Plan Commission

Monday, September 25, 2017

SUBJECT: Recommendation regarding a Site Plan for a new building and parking lot for Midland Plastics INC at the 1400 Block of Richco Court (Parcel WD-L179). Submitted by Midland Plastics INC.

SUBJECT: Recommendation regarding a Site Plan for a building addition for Kay Distributing Co. at 1881 Commerce Drive (Parcel ED-344-102-1). Submitted by Heyrman Construction Co. INC.

C5.0

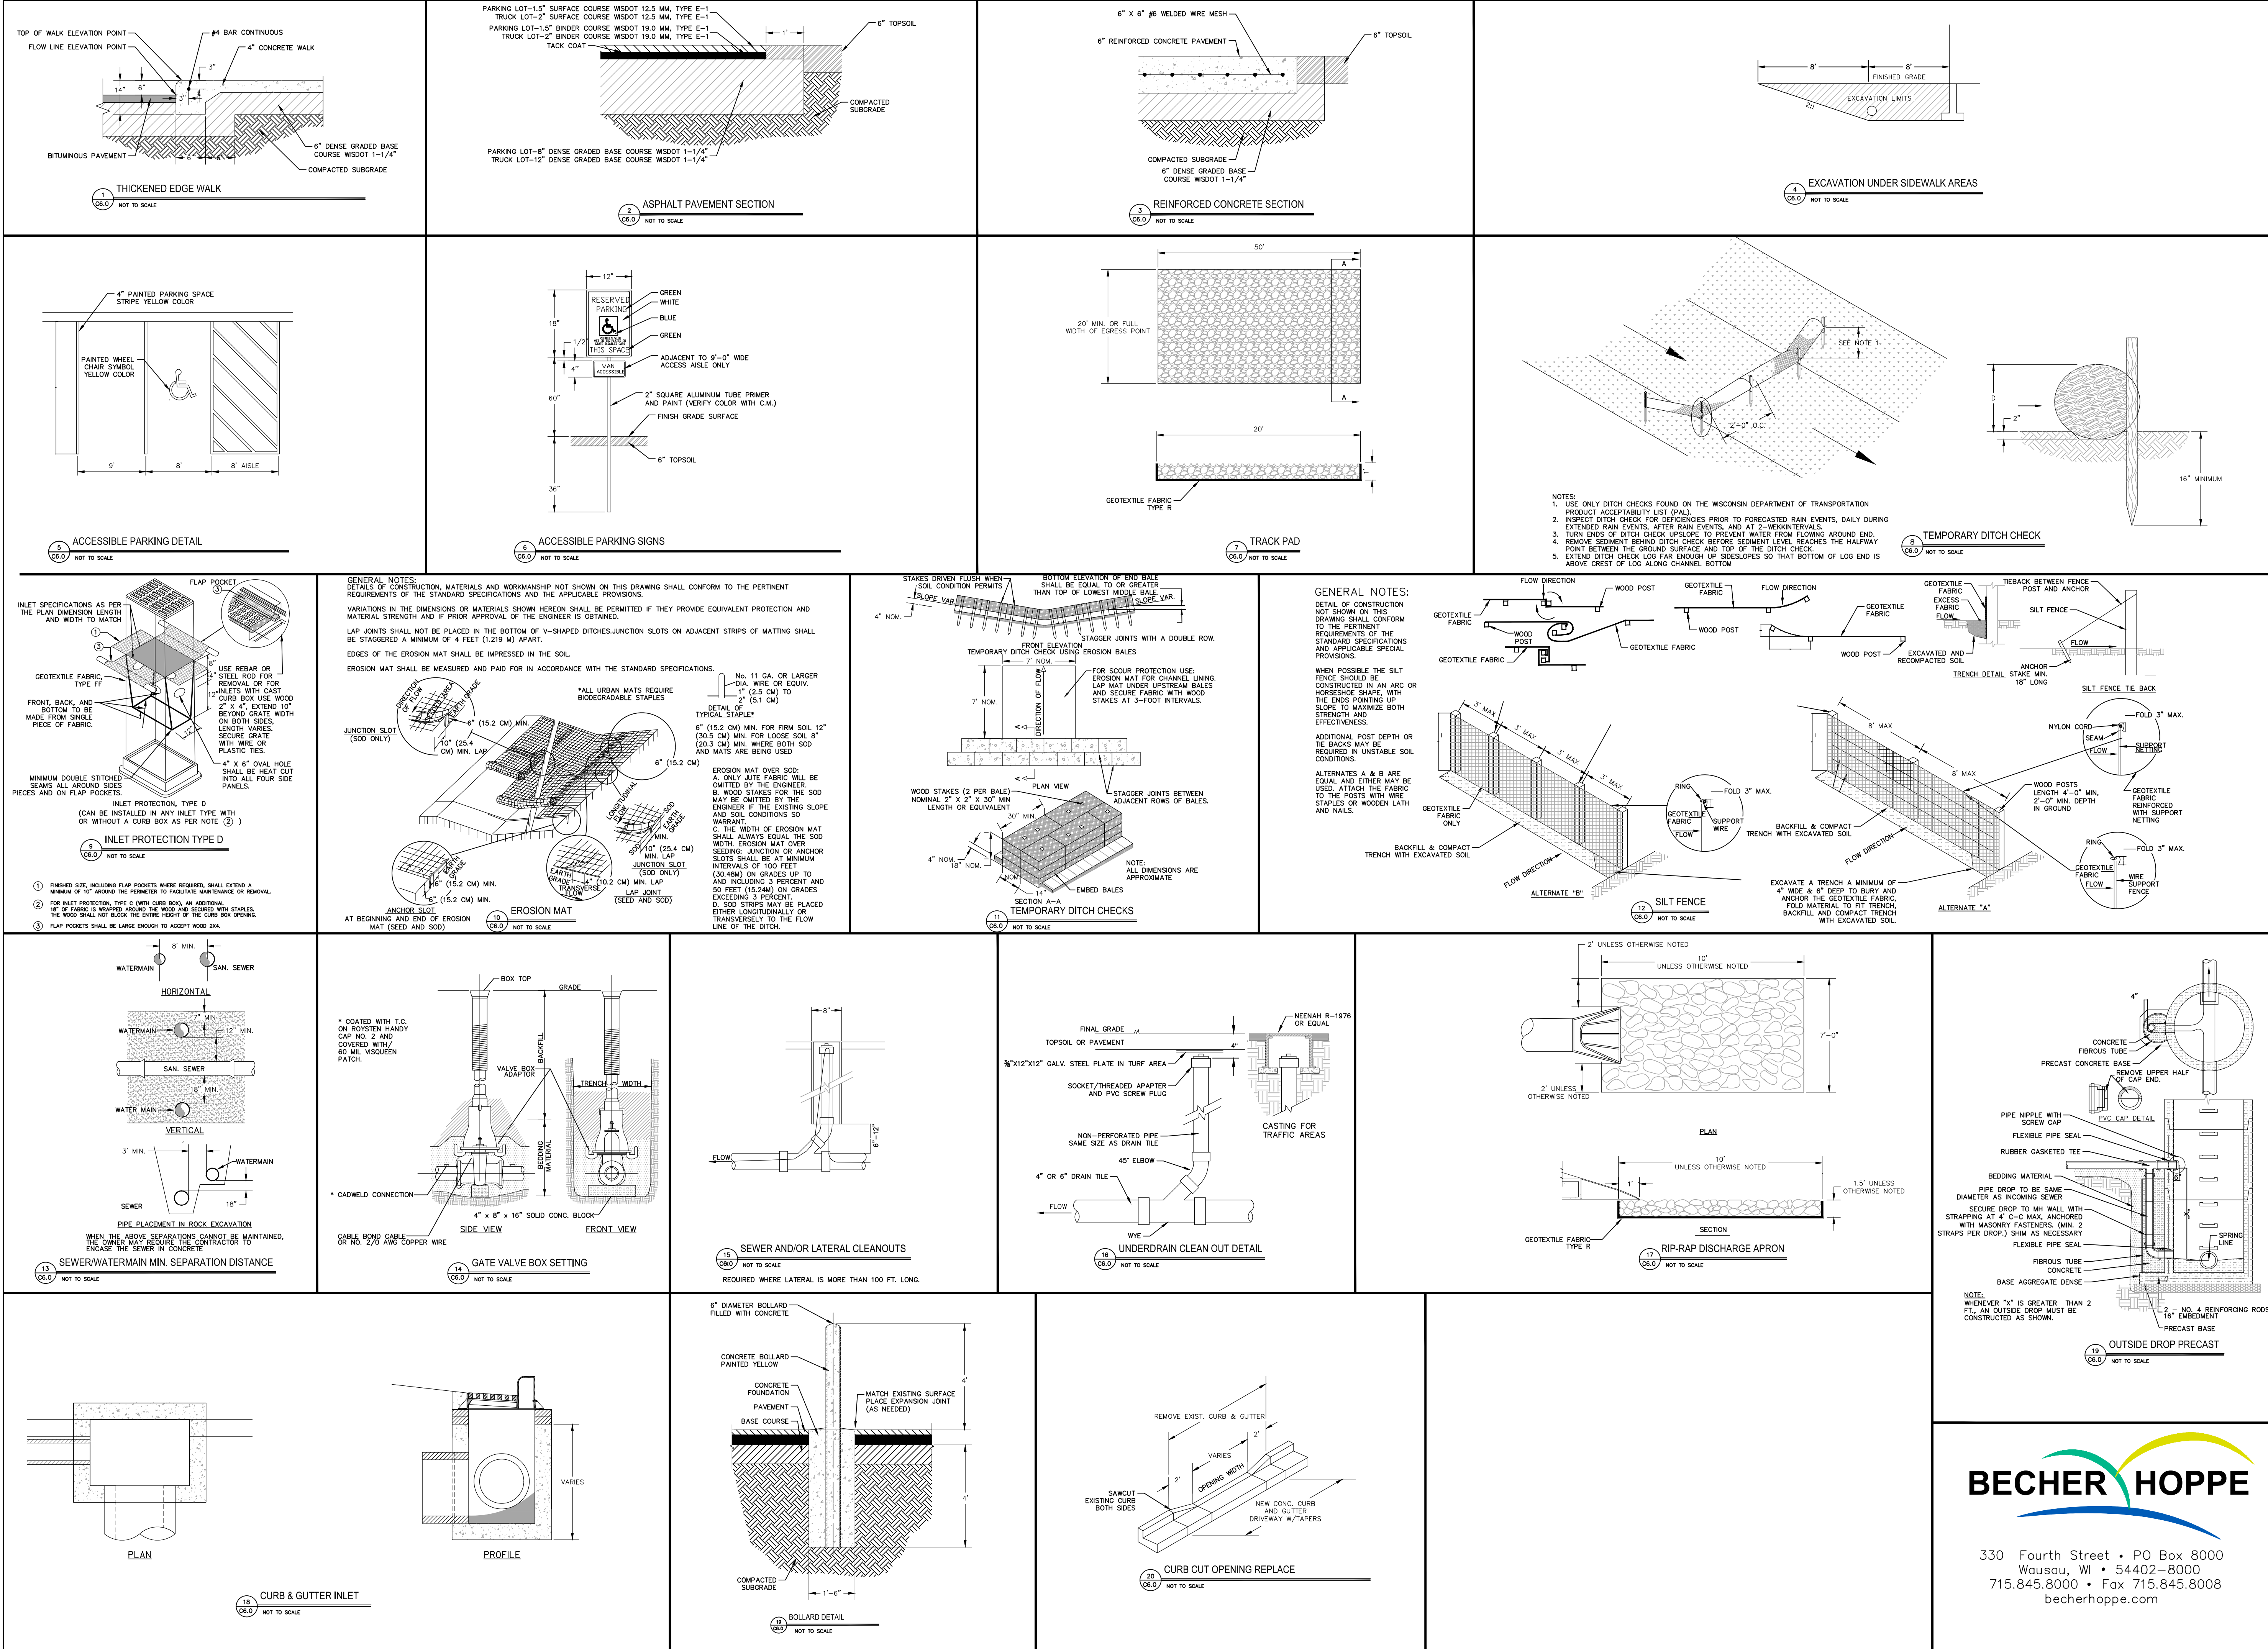
4. Provide an exterior lighting plan including a photometric plan.
5. Sheet C5.0: Need to include a note that an excavation permit will need to be purchased through City of De Pere Public Works to for all work in the City right-of-way. Please contact 920-339-4061 for permit.

8. Sheet C5.0: Please provide size, material, and length for all sewer laterals on the property. Information is only provided for the first 16' of the storm sewer lateral.

SOUTH ELEVATION
SCALE: 1/8"=1'-0"

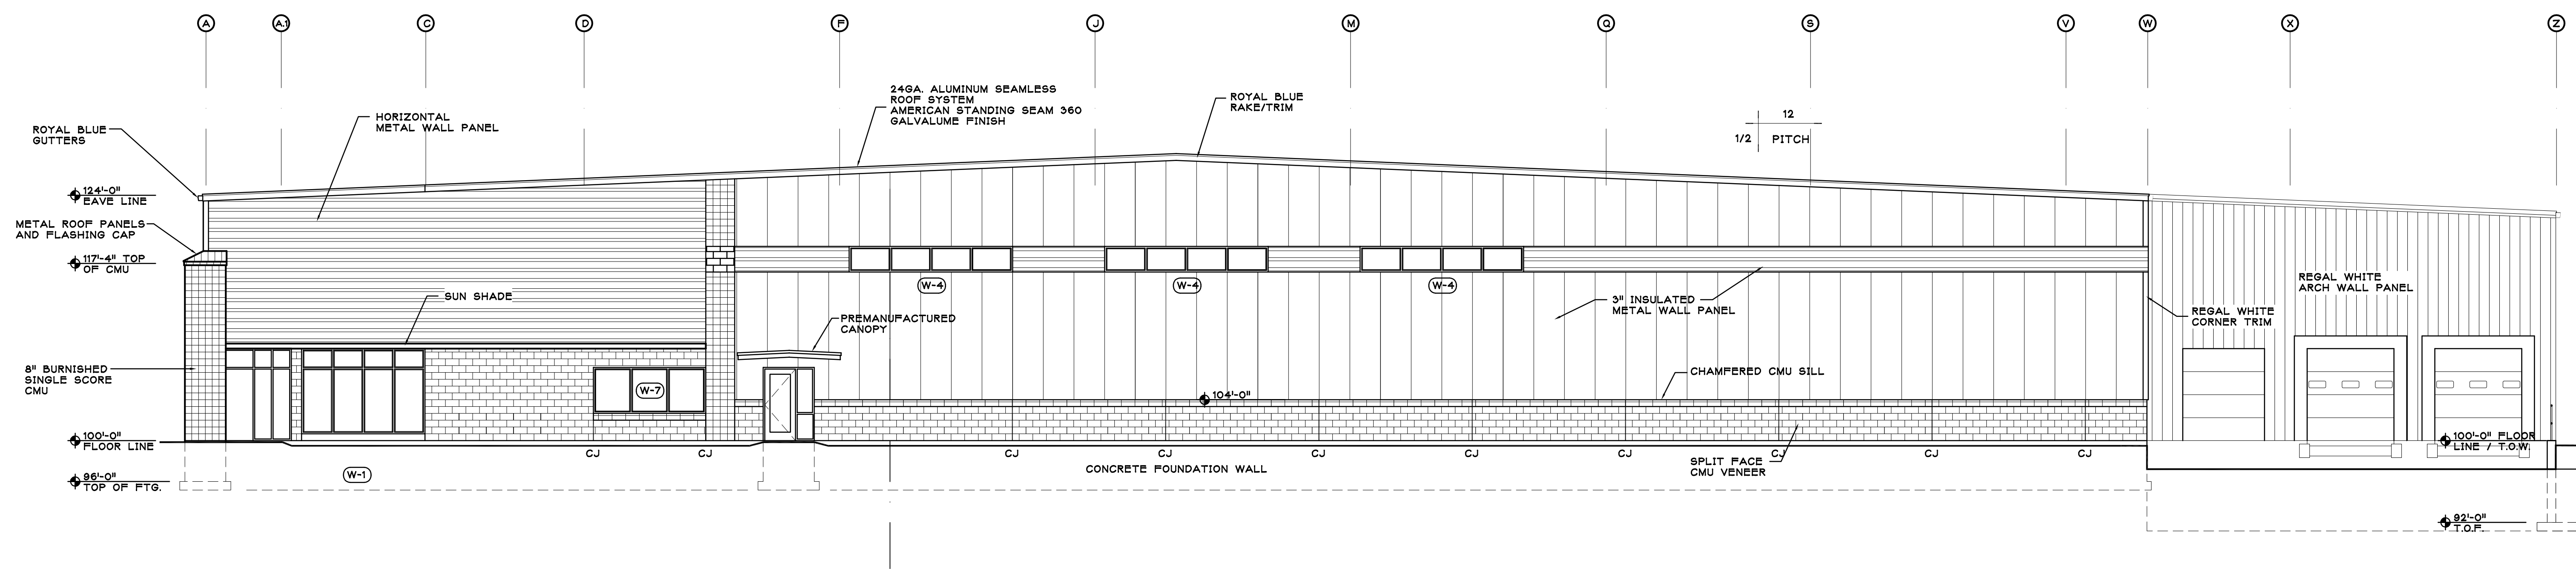
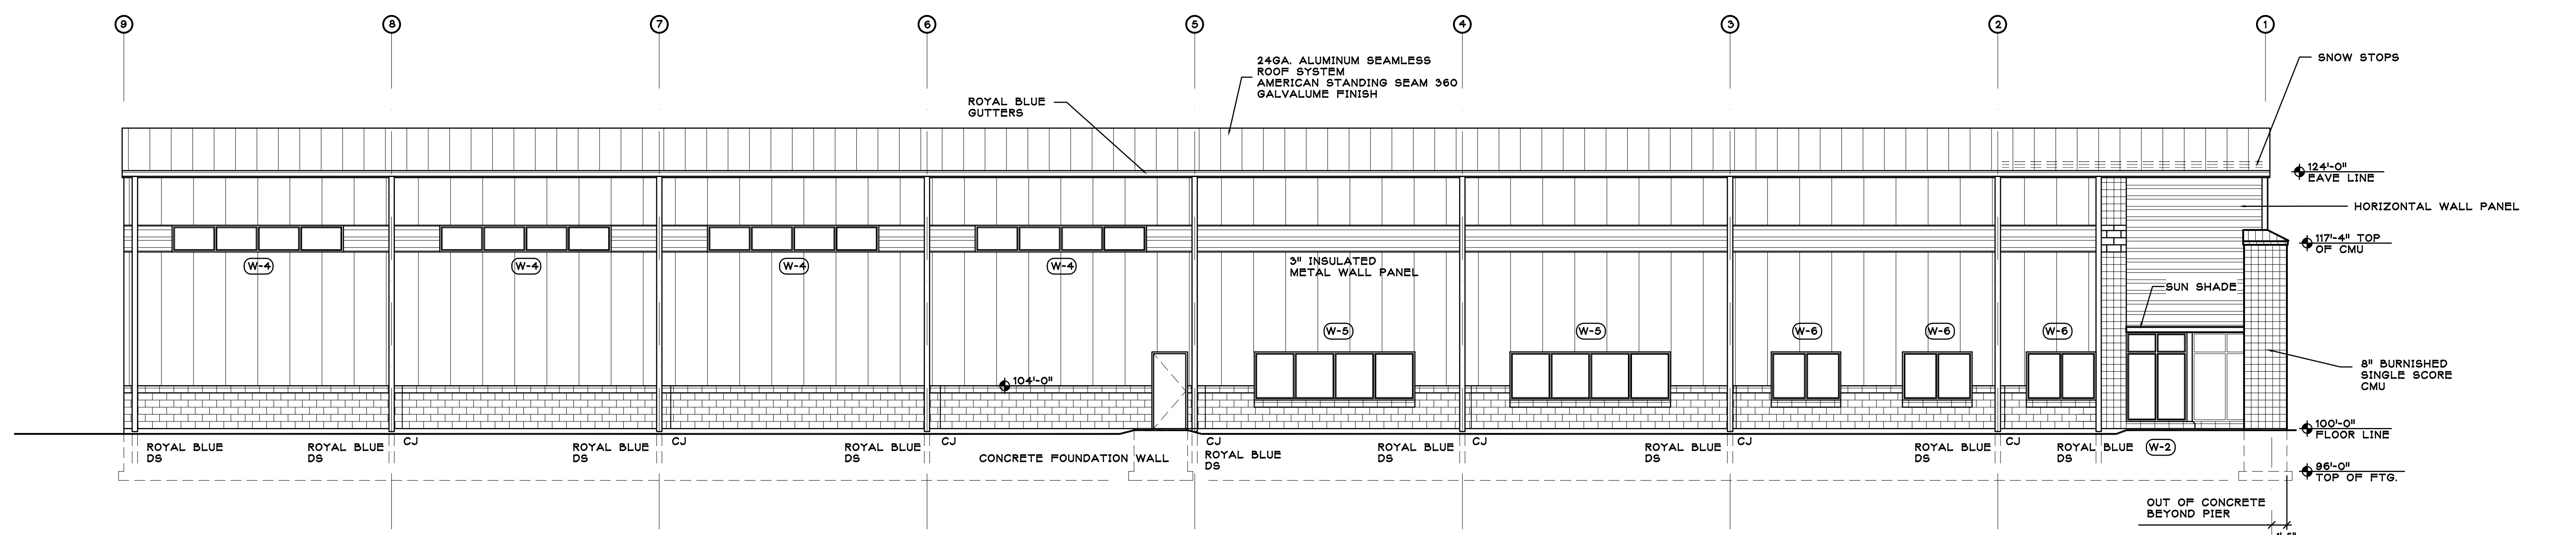
The site plan proposes a building and additional parking. The building materials include CMU, architectural wall panel, and insulated metal wall panel. The architectural wall panel may be considered allowable as an "other material" if approved by Plan Commission, per Municipal Code 14-60(6)(c)(7). The architectural panel is visible from the street on the south and west sides of the building, along with approximately 4-feet of CMU at the base of the wall. Colors for the building are regal white and blue. Staff does not have an updated 3-D rendering of the building as the site plan elevations changed recently. Updated 2-D renderings are attached to this report.

- The area of landscaping between the walkway and the building should be expanded from approximately 3 feet wide to 5 feet wide and vegetated. The present plan does not call out any plants in the area.
- The area of CMU on the south and west sides of the building should be increased from about 4-5 foot high to the height of the doors and windows, if insulated architectural paneling is to be approved as part of the site plan.

The staff recommendation includes Plan Commission approving the use of insulated architectural paneling on the building with the increased use of CMU on the south and west sides.

Site plan with proposed building addition, drive, and Landscape Plan

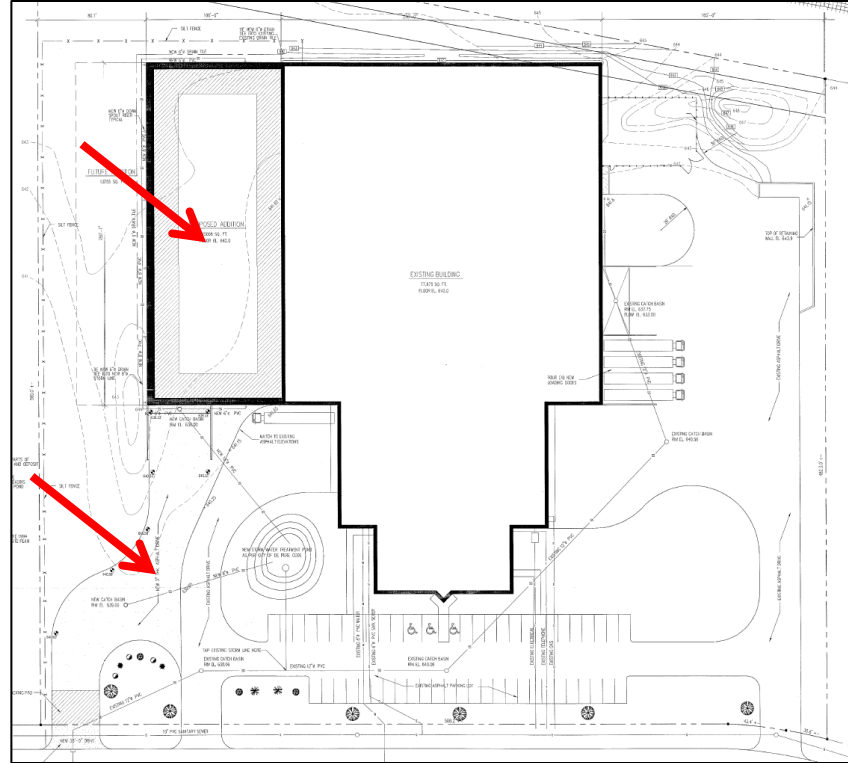
An original landscaping plan had simple berms at the north west end of the property, near the street. At staff's suggestion, the berms were replaced with vegetation along the full length of the property near the right-of-way. It appears that 16 plants and trees are proposed.

There are three driveways shown on the site plan. The drive at the south end and the drive in the north-center of the property are pre-existing. The drive at the north end is part of the proposed addition. As shown, the drive is approvable, provided the drive is one way with signage indicating traffic flow. Also, the drive requires a simple sidewalk section.
